SERVICE BULLETIN

ENGINE - LP TURBINE - REPLACE THE EXISTING NO.5 BEARING SEAL SPACER WITH A SPACER INCORPORATING FOOL-PROOF INSTALLATION FEATURES - CATEGORY CODE 5 - MOD.ENG-72-0165

V2500-ENG-72-0165

Location of the No.5 Bearing Seal Spacer
Fig.1

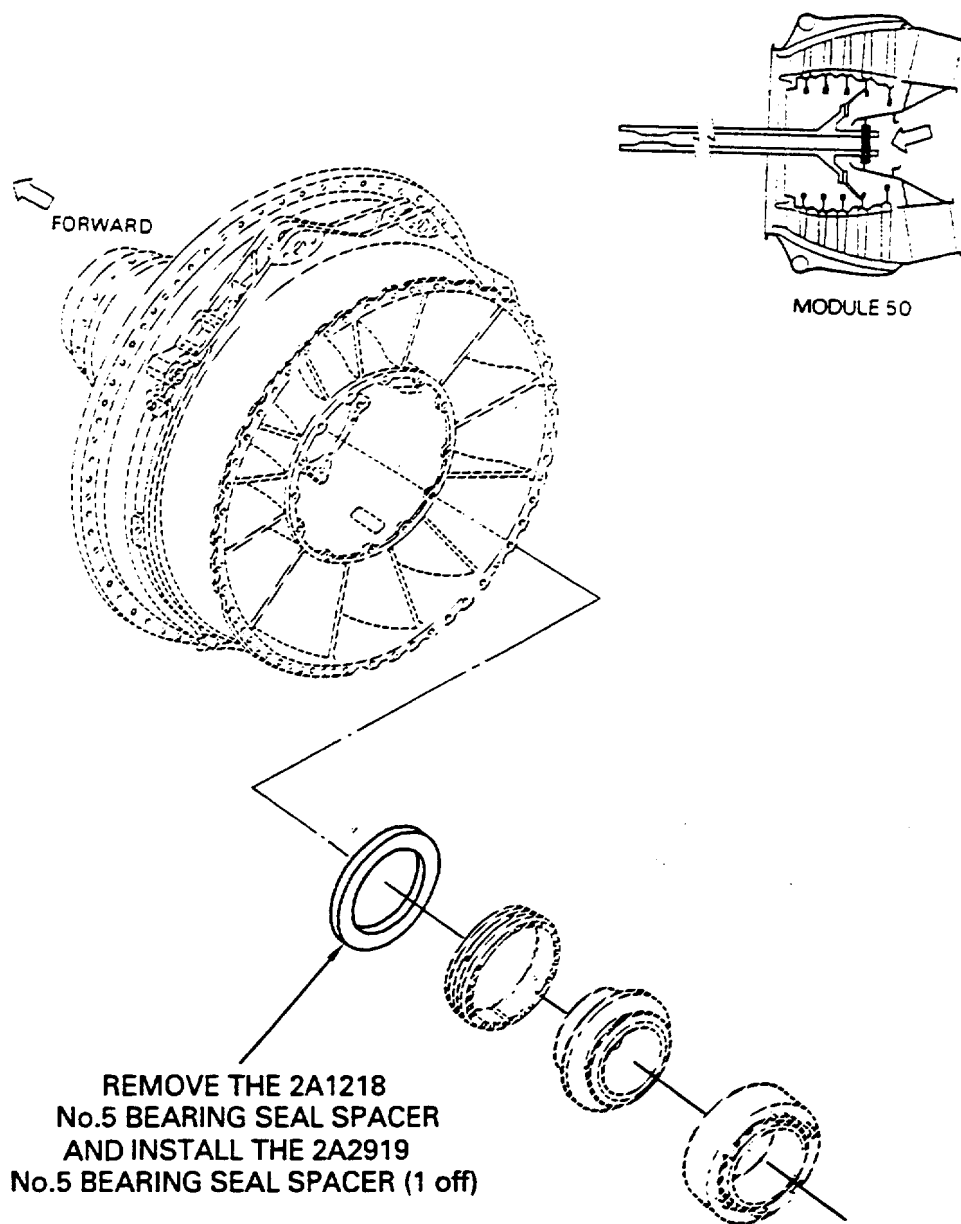
Replace the No. 5 bearing Seal Spacer with one that has features to prevent its installation in a position that is not correct.

- (1) For V2500-A1 and V2500-A5 Engines
 - (a) Remove the 2A1218 No. 5 Bearing Seal Spacer by the approved procedure given in Reference (2), Chapter/Section 72-50-00, Disassembly-01.
 - (b) Install the 2A2919 No. 5 Bearing Seal Spacer (1 off) by the approved procedure given in Reference (2), Chapter/Section 72-50-00, Assembly-02, and Figure 1.
- (2) For V2500-D5 Engines
 - (a) Remove the 2A1218 No. 5 Bearing Seal Spacer by the approved procedure given in Reference (3), Chapter/Section 72-50-00, Disassembly-01.
 - (b) Install the 2A2919 No. 5 Bearing Seal Spacer (1 off) by the approved procedure given in Reference (3), Chapter/Section 72-50-00, Assembly-02, and Figure 1.
